# SAFETY EVALUATION REPORT

**DECEMBER 1997**

HYDRO RESOURCES, INCORPORATED  
LICENSE APPLICATION FOR  
CROWNPOINT URANIUM SOLUTION MINING PROJECT  
MCKINLEY COUNTY, NEW MEXICO

DOCKET NO. 40-8968

Figure 1. HRI Organization Chart.

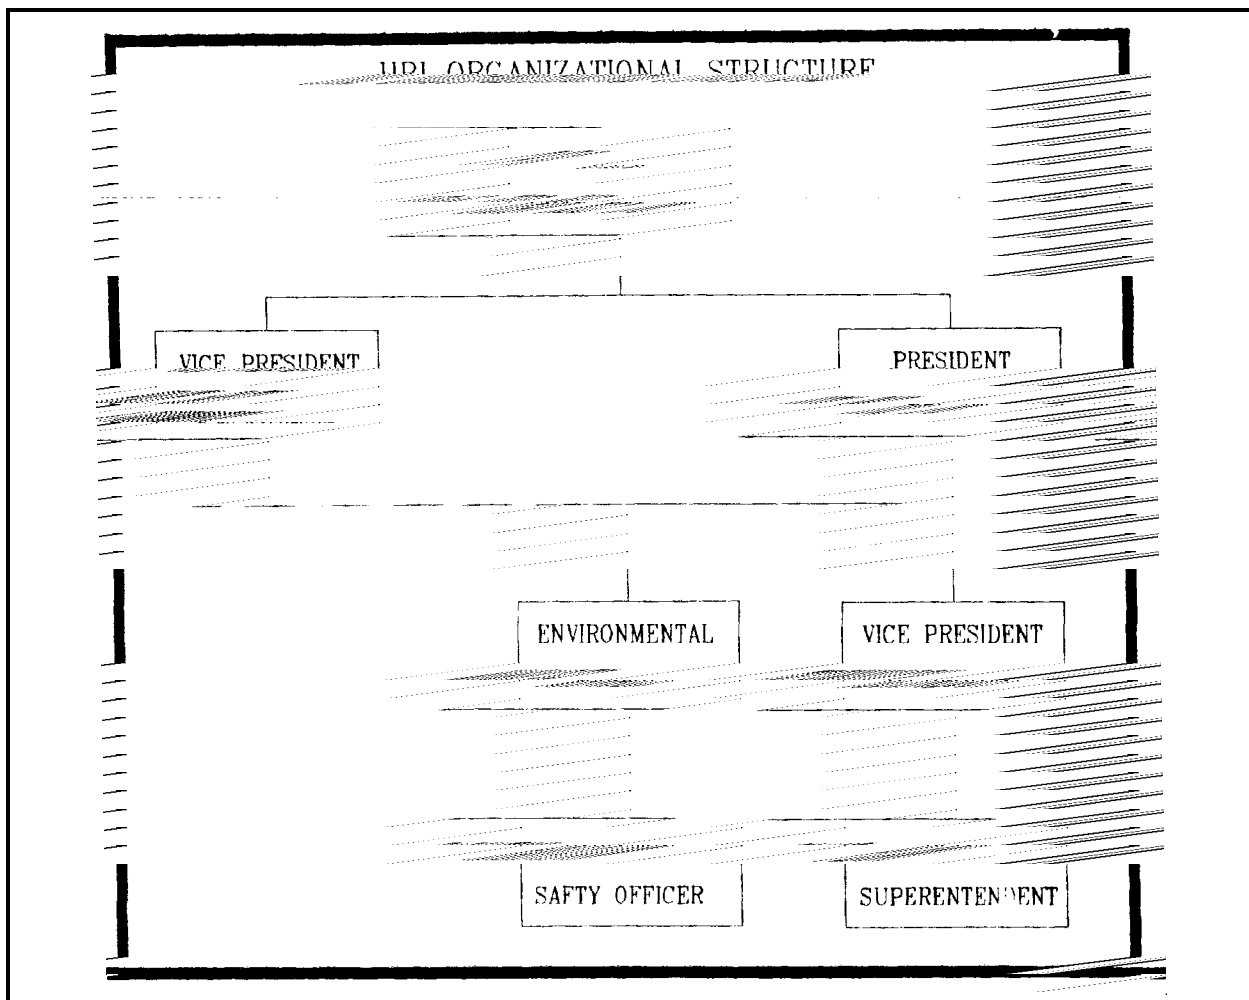
Figure 1 is a partial organization chart of HRI's Crownpoint Project. The positions and duties of HRI personnel are described below, in descending order of authority. Qualifications and experience requirements are noted, where applicable. HRI will allow a Master's degree in an appropriate field to equate to two years of work experience. HRI's organizational arrangement is consistent with Regulatory Guide 8.31 (NRC 1983b). The organizational arrangement allows radiation safety matters to be considered at any management level. To ensure clear lines of communication for radiological safety matters, NRC will require by license condition that:

**Any corporate organization changes affecting the assignments or reporting responsibilities of the radiation safety staff as described in the COP of the approved license application shall conform to Regulatory Guide 8.31 (NRC 1983b).**
